Addendum No. 001

Subject: William Rowen School – Classroom Modifications
SDP Contract Nos. B-063C, B-066C of 2017/18

This Addendum, dated May 9, 2018, shall modify and become part of the Contract Documents for the work of this project. Any items not mentioned herein, or affected by, shall be performed strictly in accordance with the original documents.

DRAWING NO.
E122

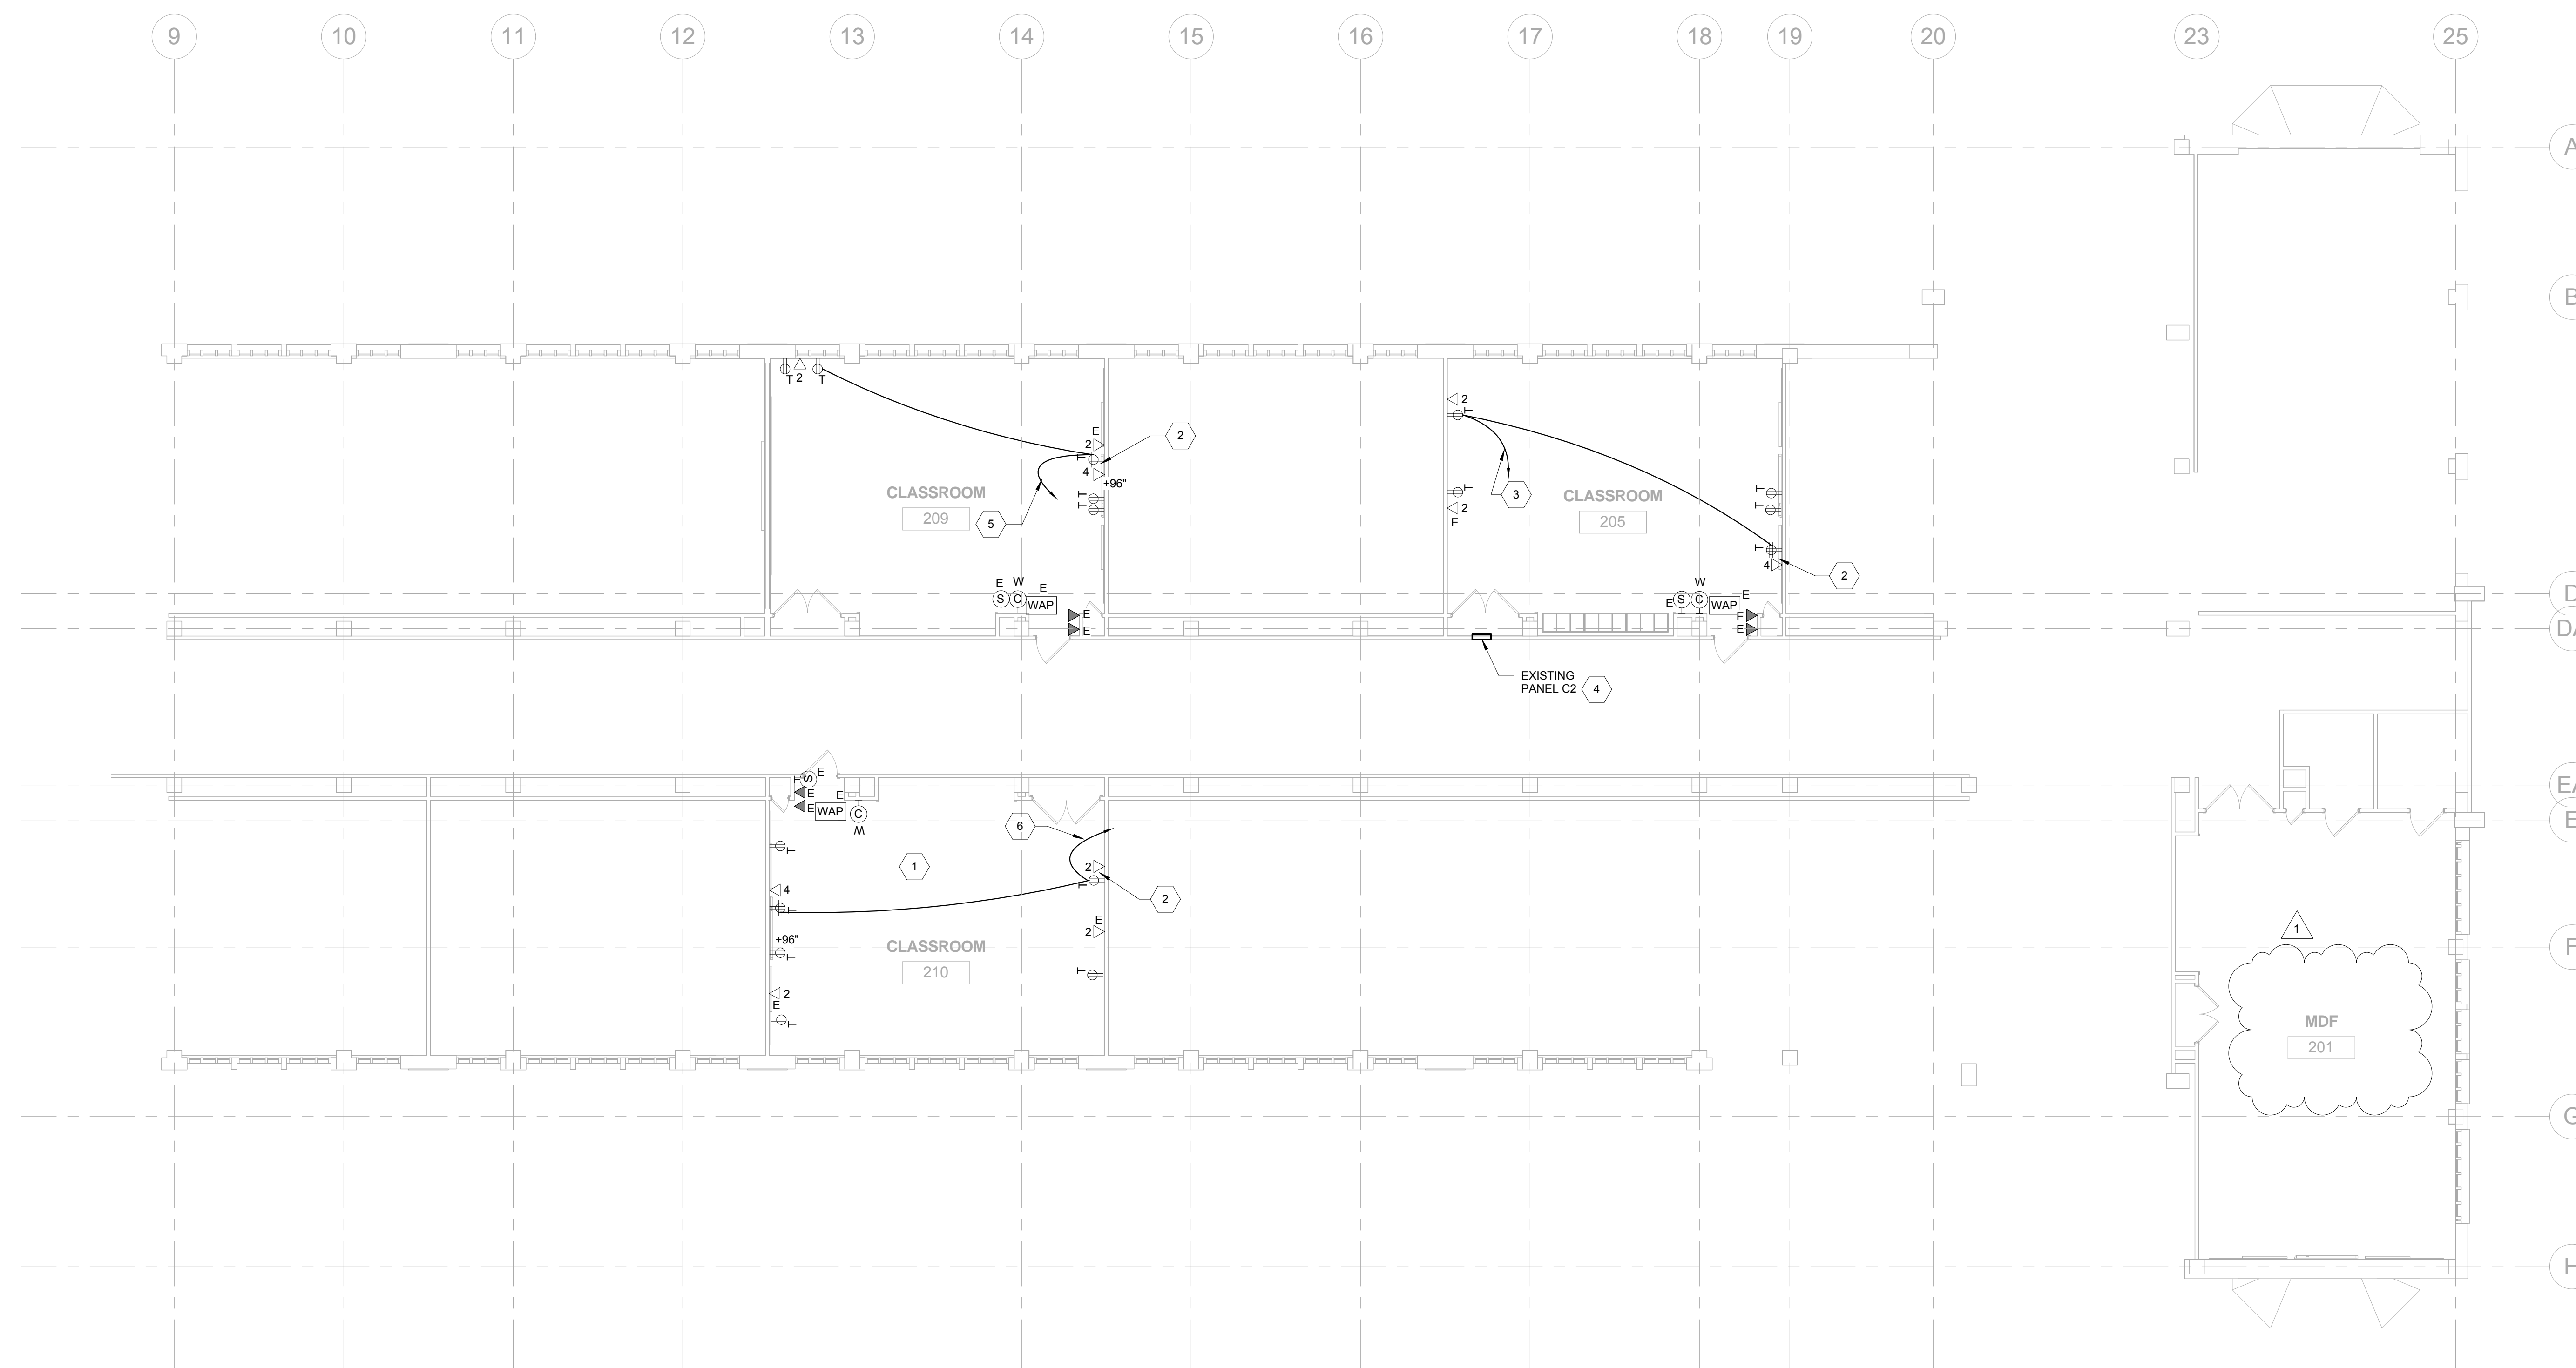
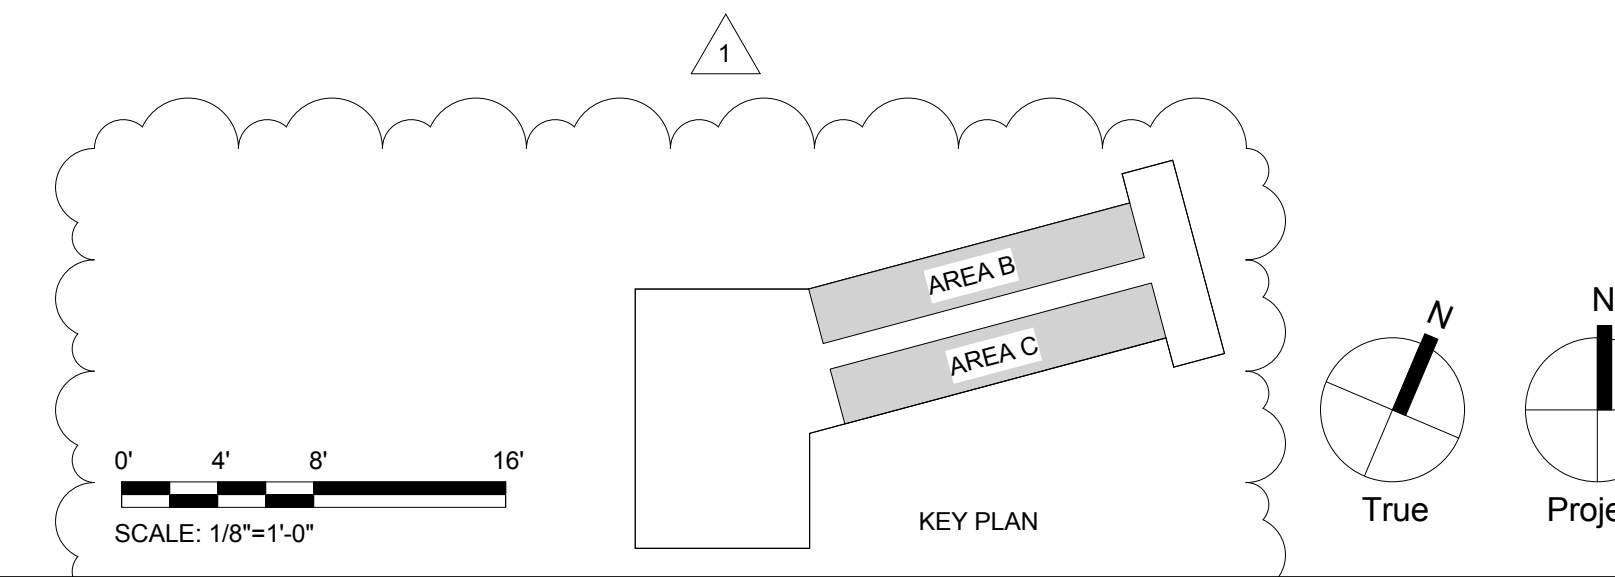
- Revisions:
a. Added MDF room 201.
b. Add Key plan.

1 DATA RISER DIAGRAM NTS

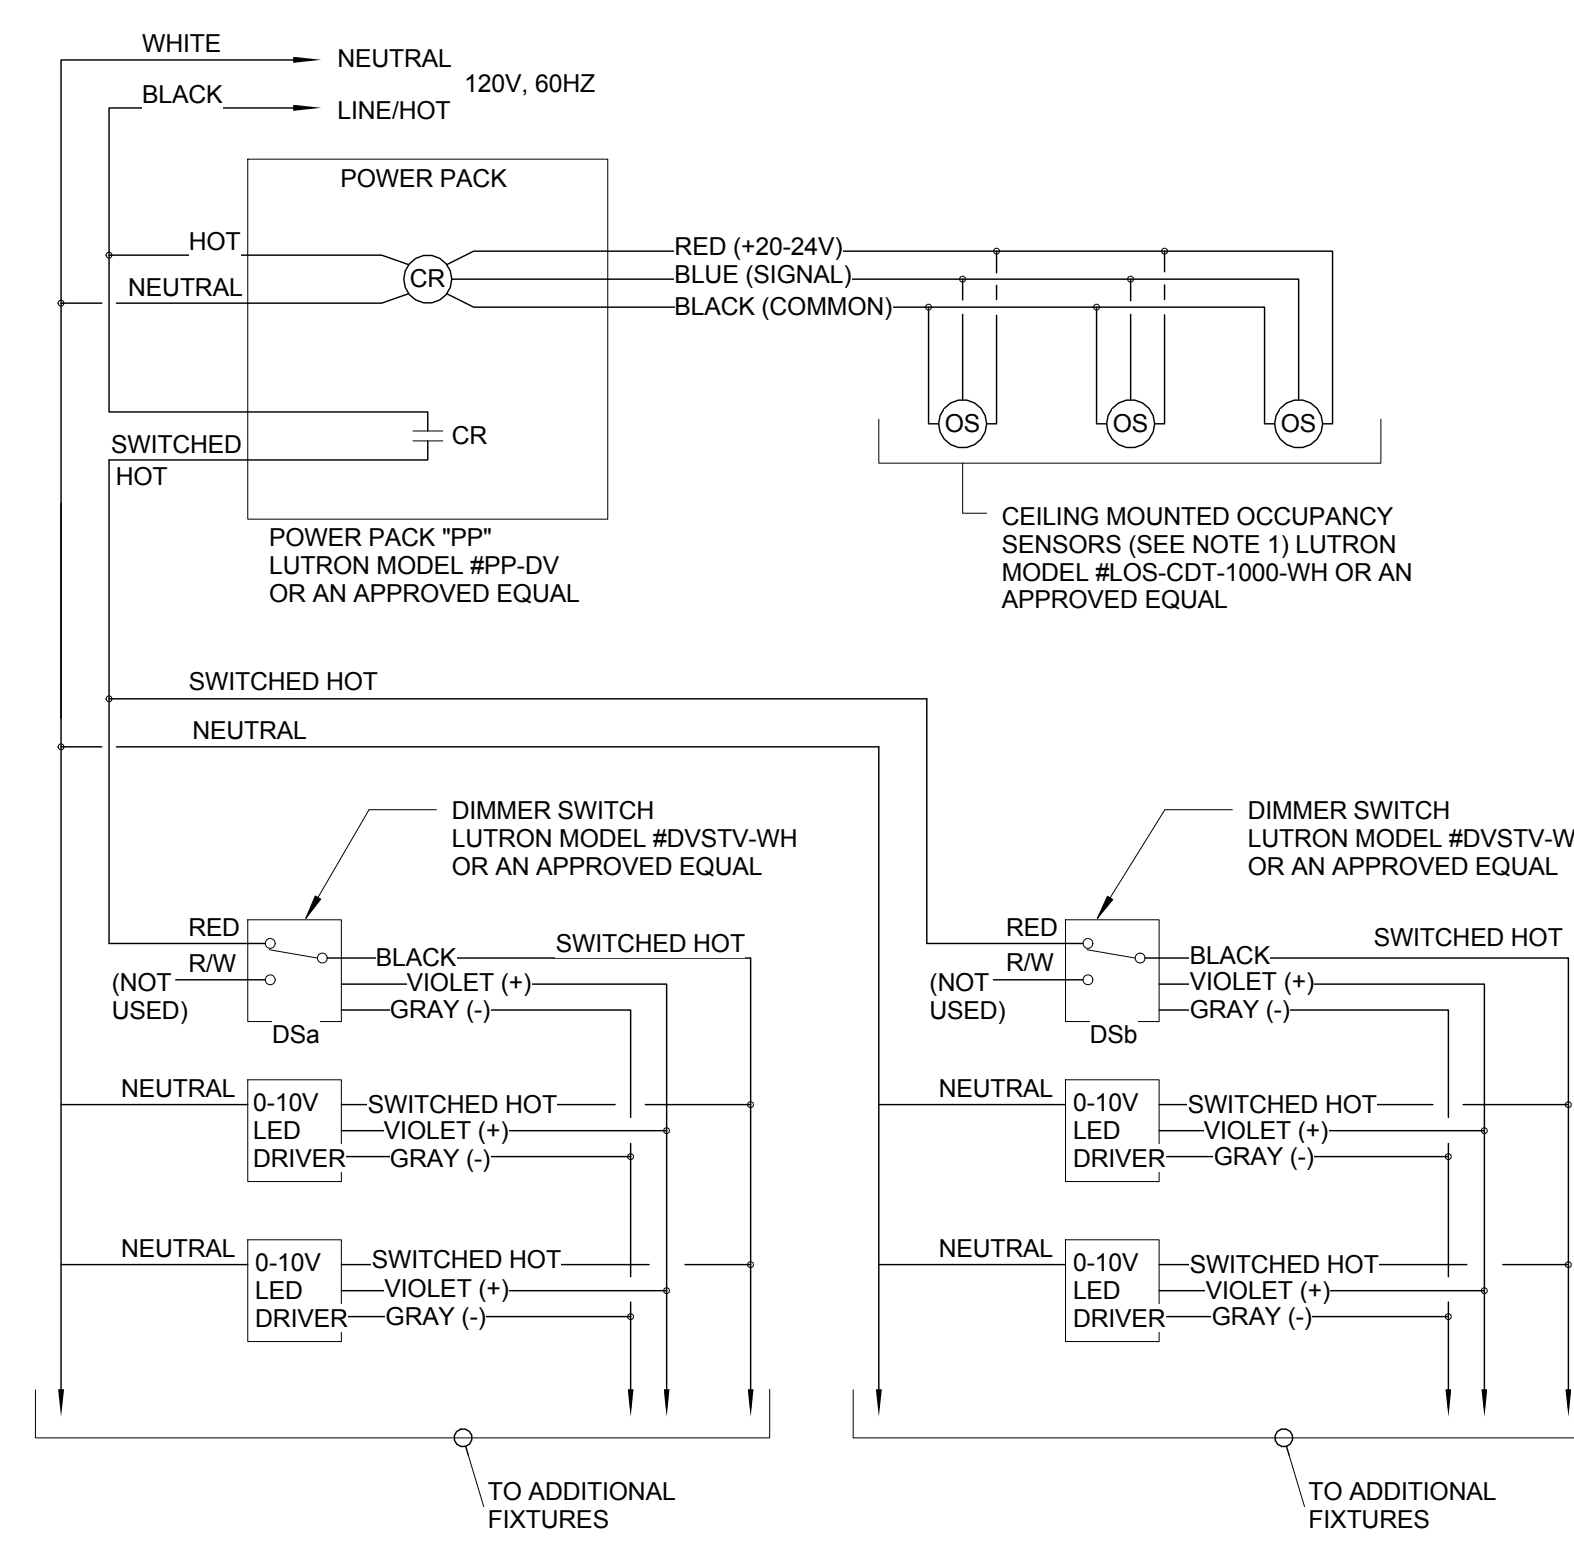
- Revisions:
a. Delete Panelboard detail.
b. Add room name and number on Data riser diagram.
